From: Scott O'Neil [sonell@proconinc.com]
 Sent: Thursday, May 03, 2007 10:22 AM
 To: Larry Ross
 Cc: Randy Allred; Craig Hill; Matt Labonte
 Subject: RE: Roof sketch
 Follow Up Flag: Follow up
 Flag Status: Red

CUSTOM HOUSE SQUARE
 300 FORE STREET
 PORTLAND, MAINE
 WALL SECTIONS

A4.13

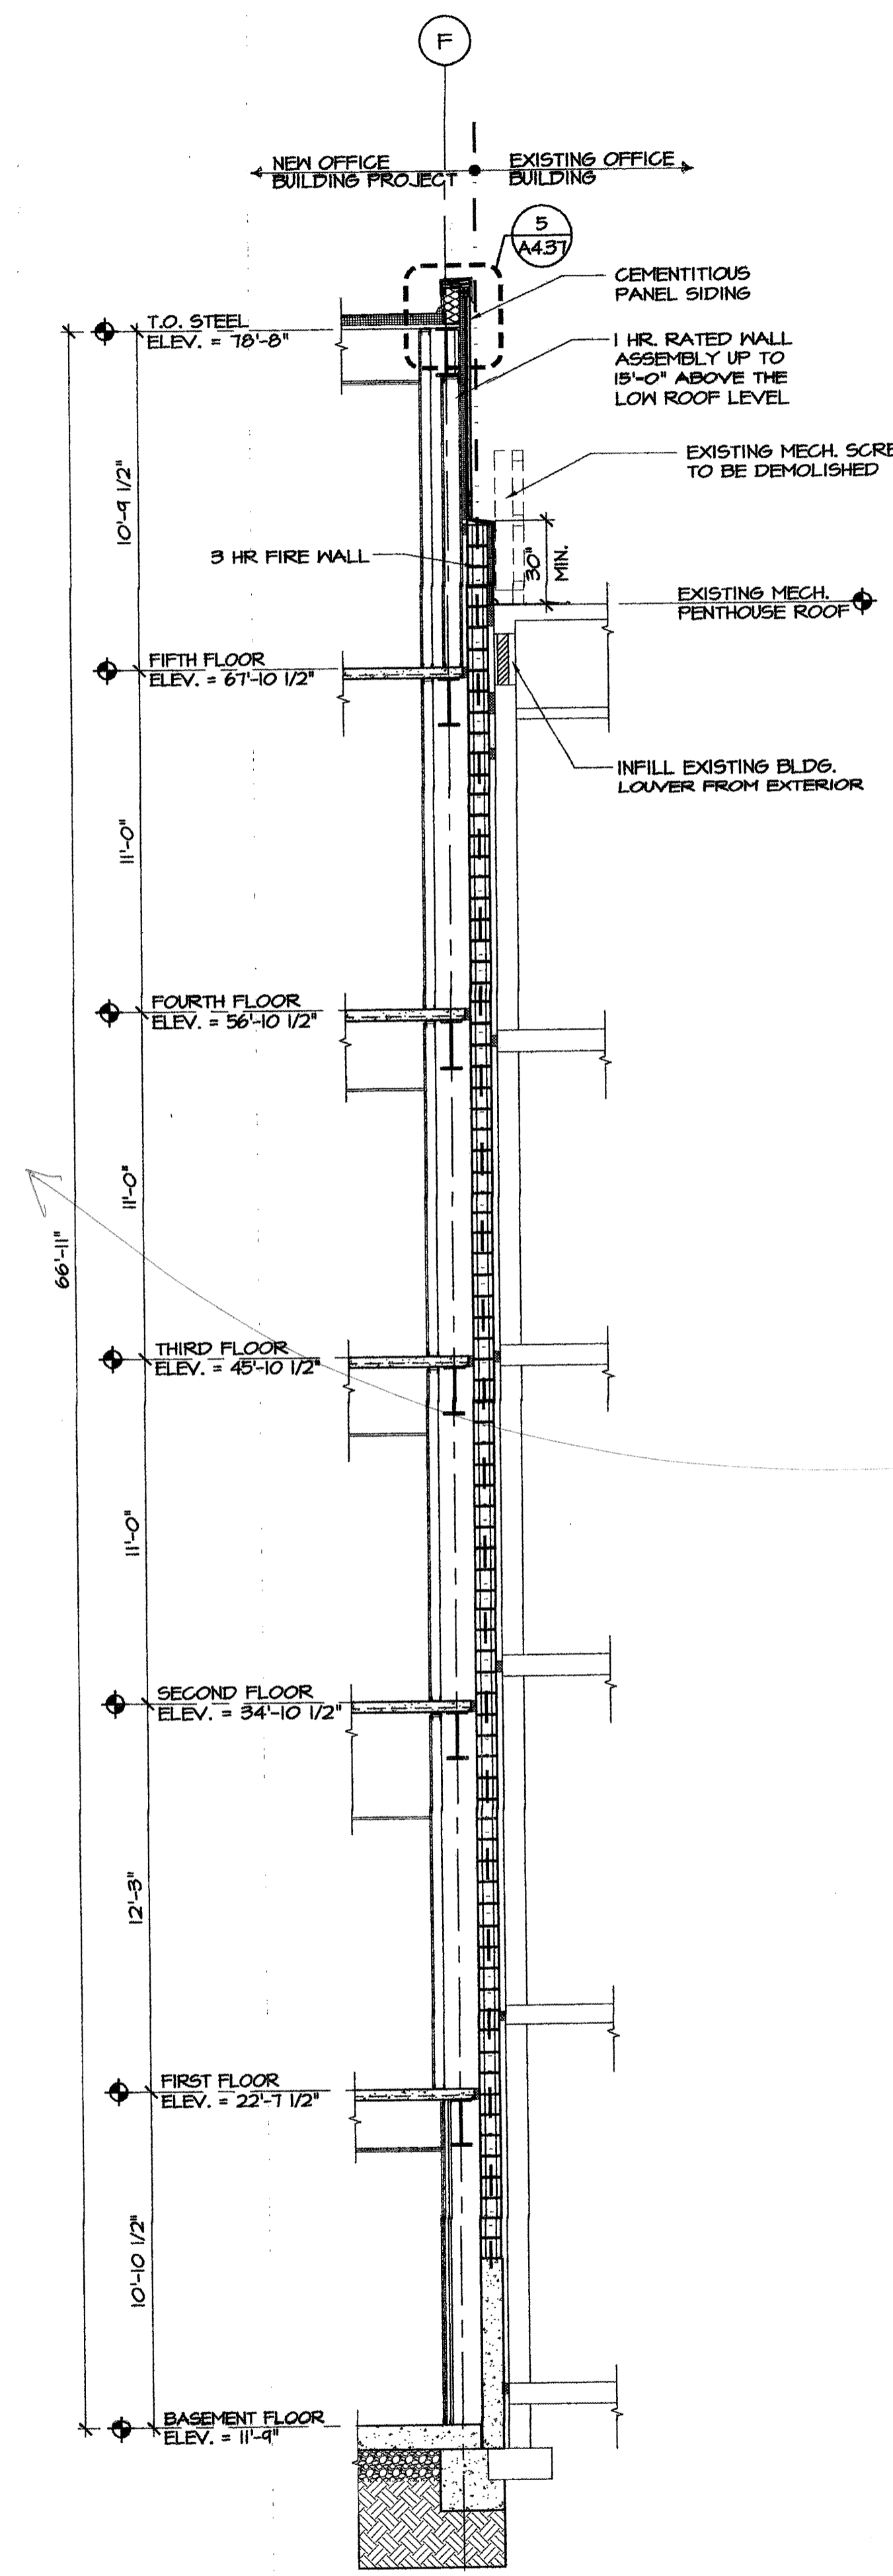
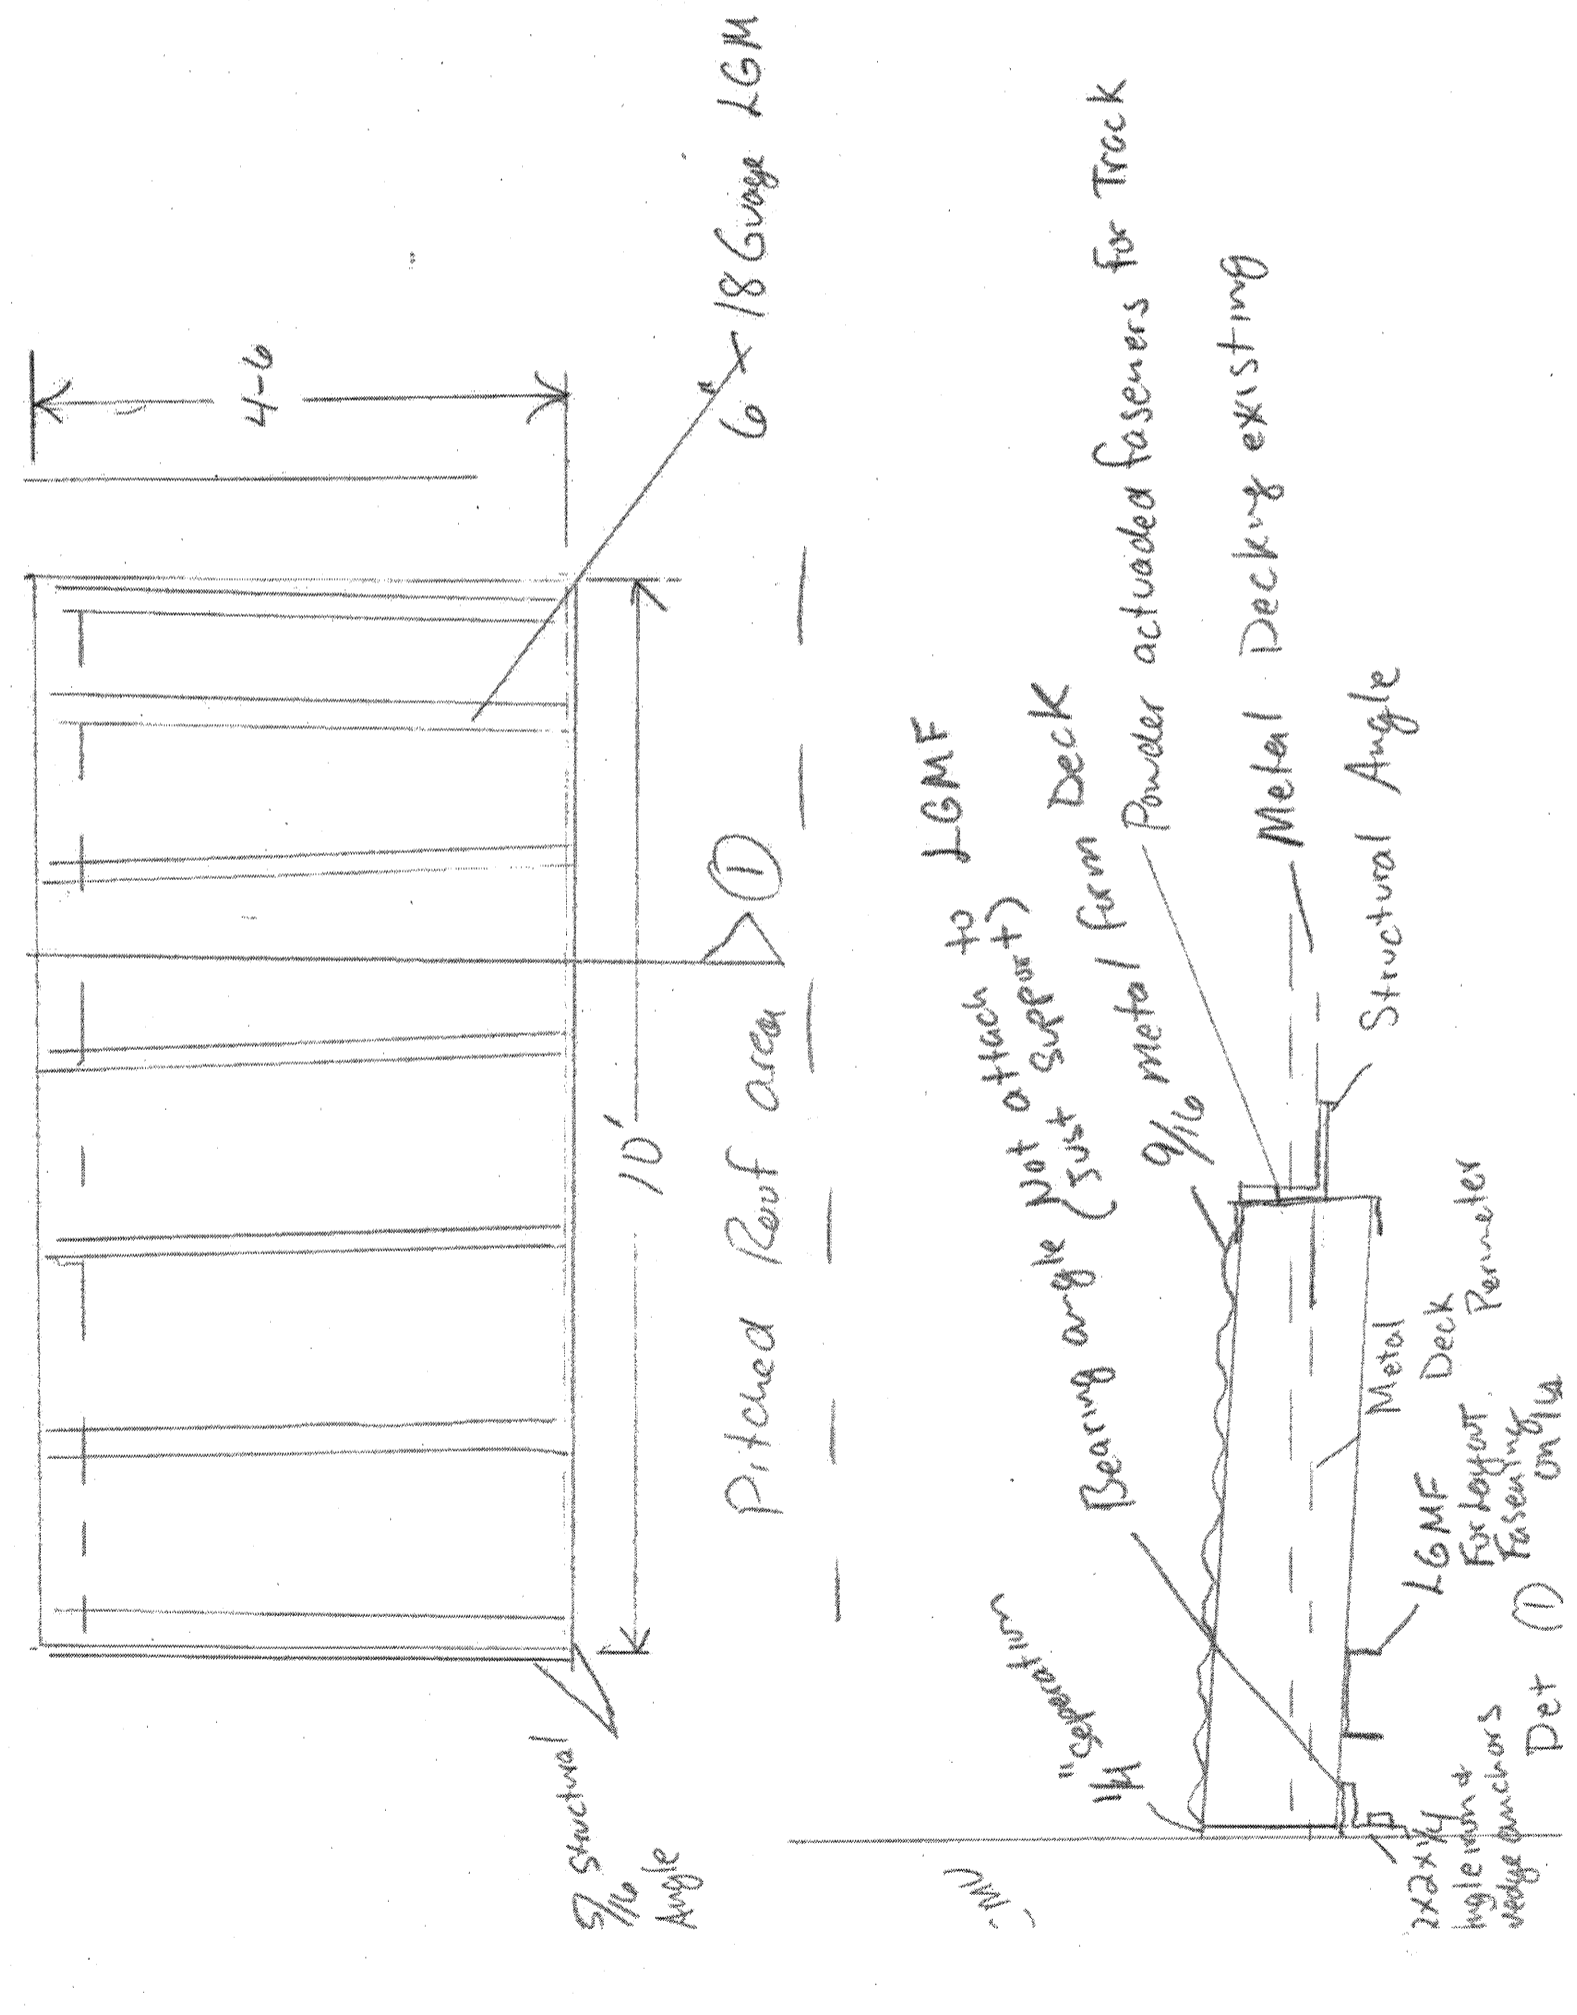
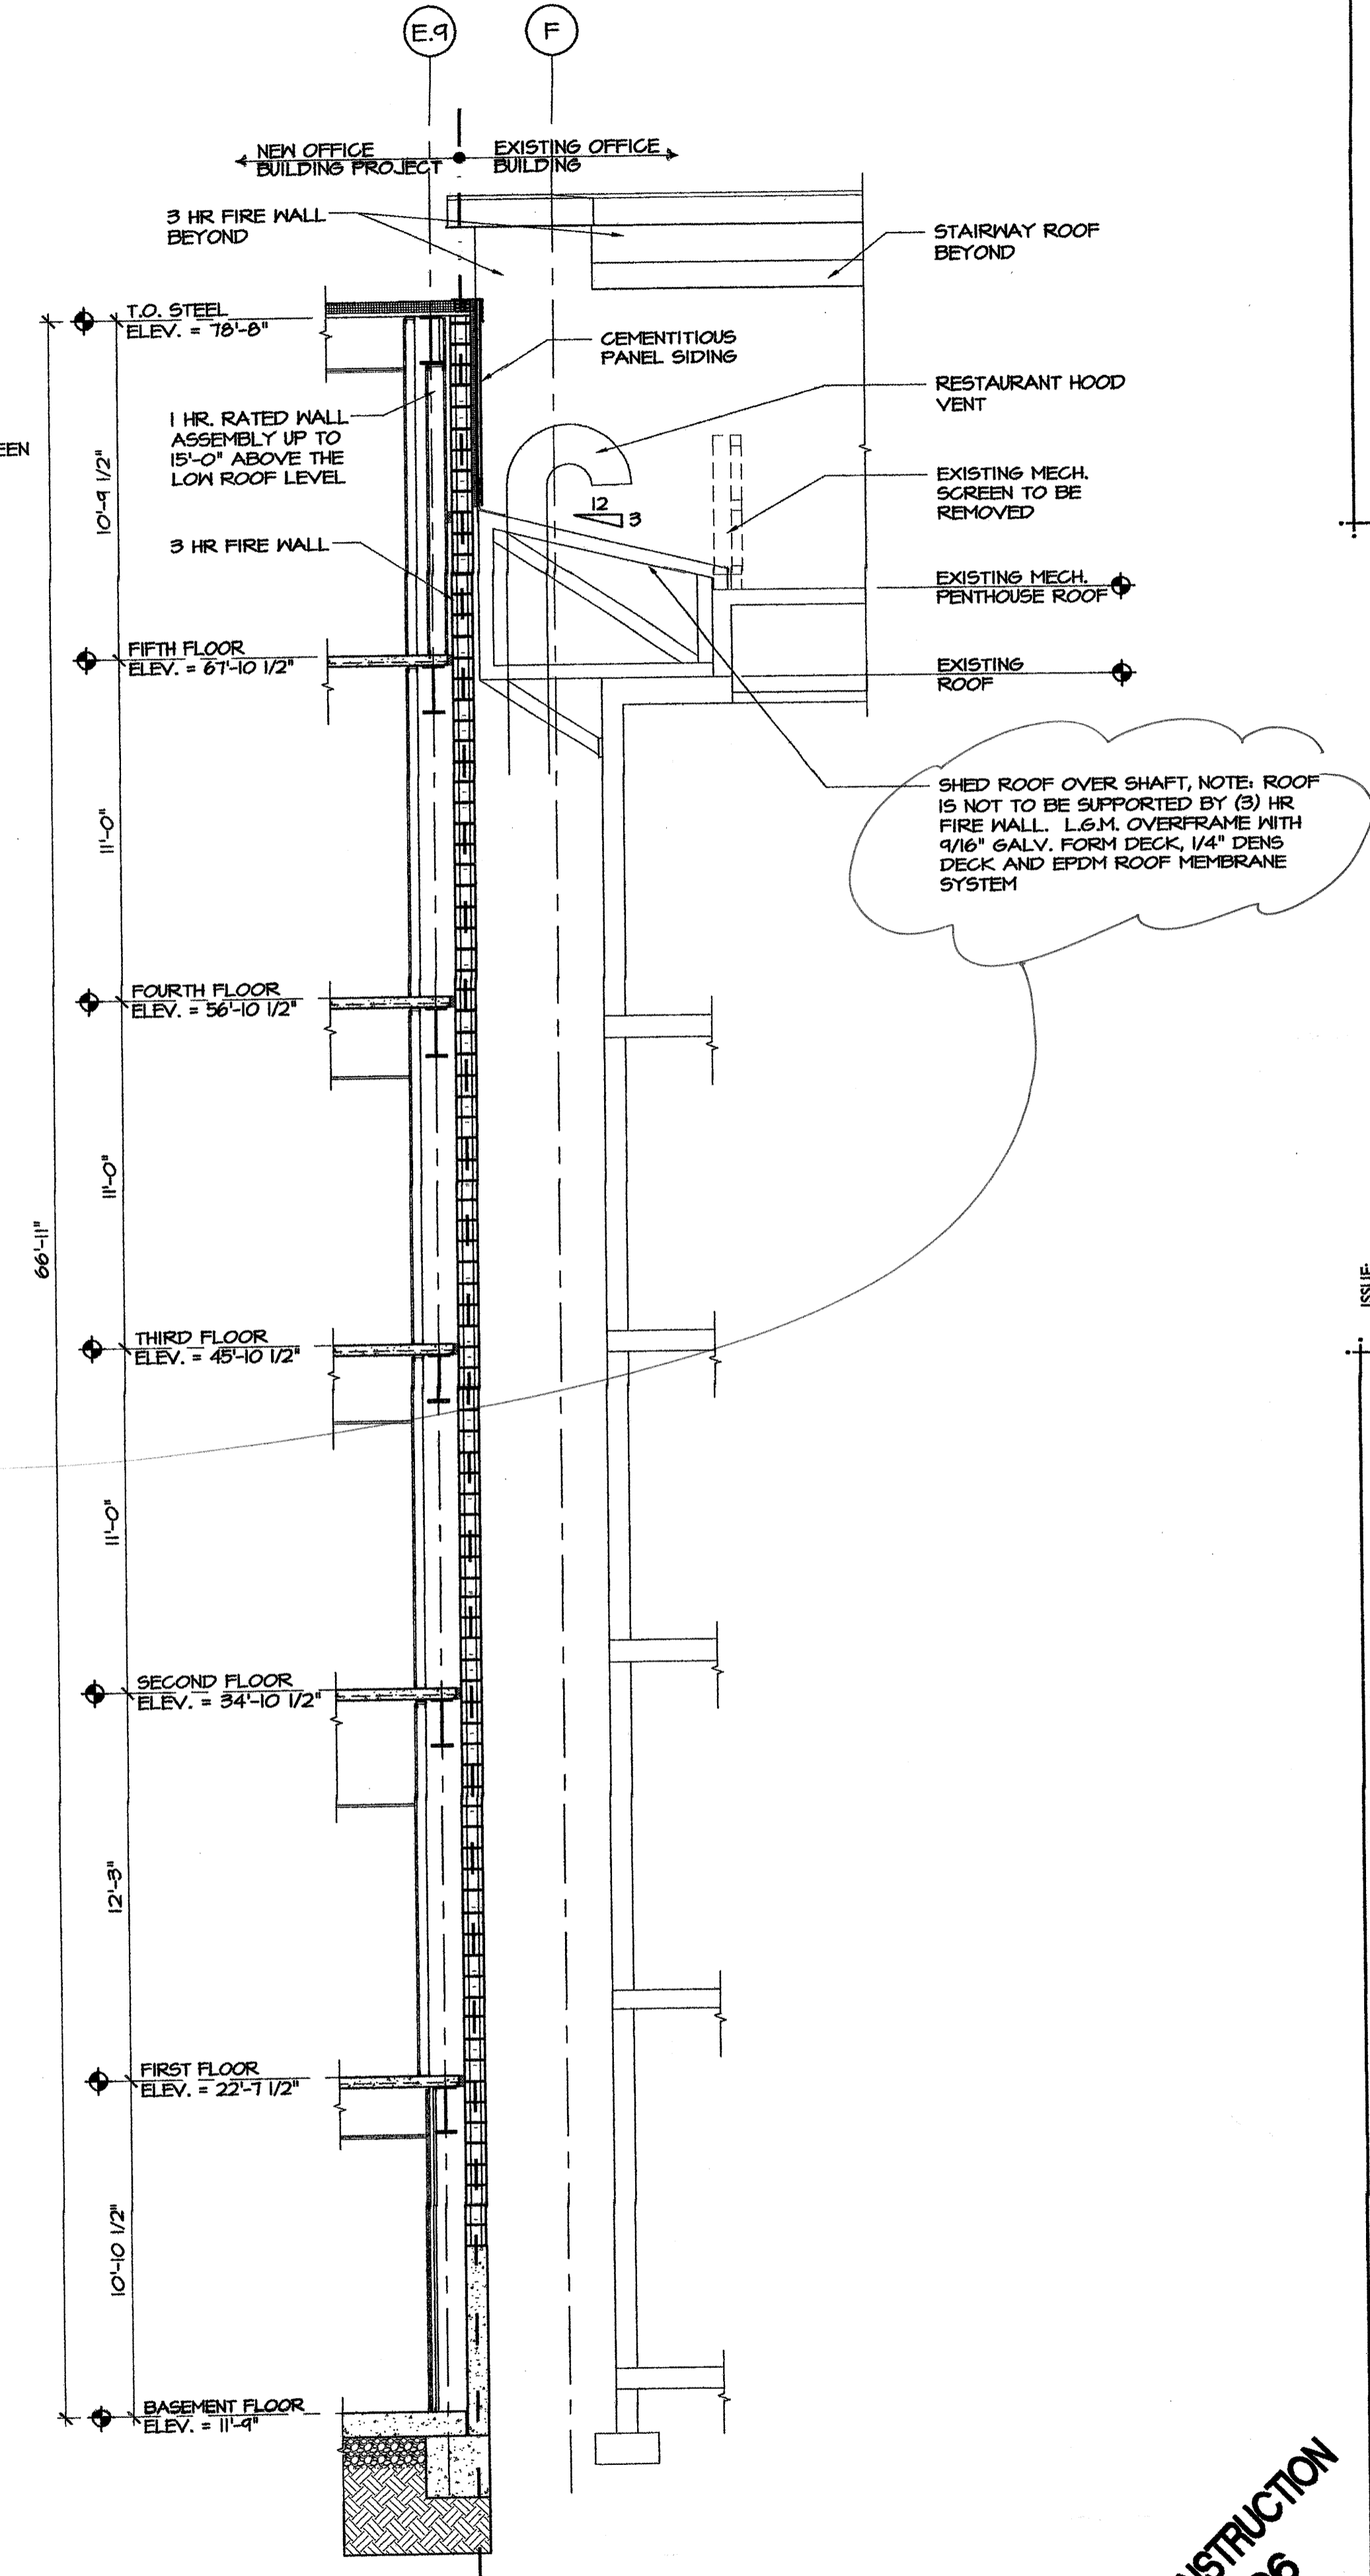
Scott see if this application will apply. Give me a call to review if necessary. Larry Ross, WRC 207-671-6854

We have reviewed your sketch for the roof over the mechanical shaft and take no exceptions to your proposal. We do want you to add a metal stud kicker back to the 2 hour CMU shaft wall at every other stud for support.
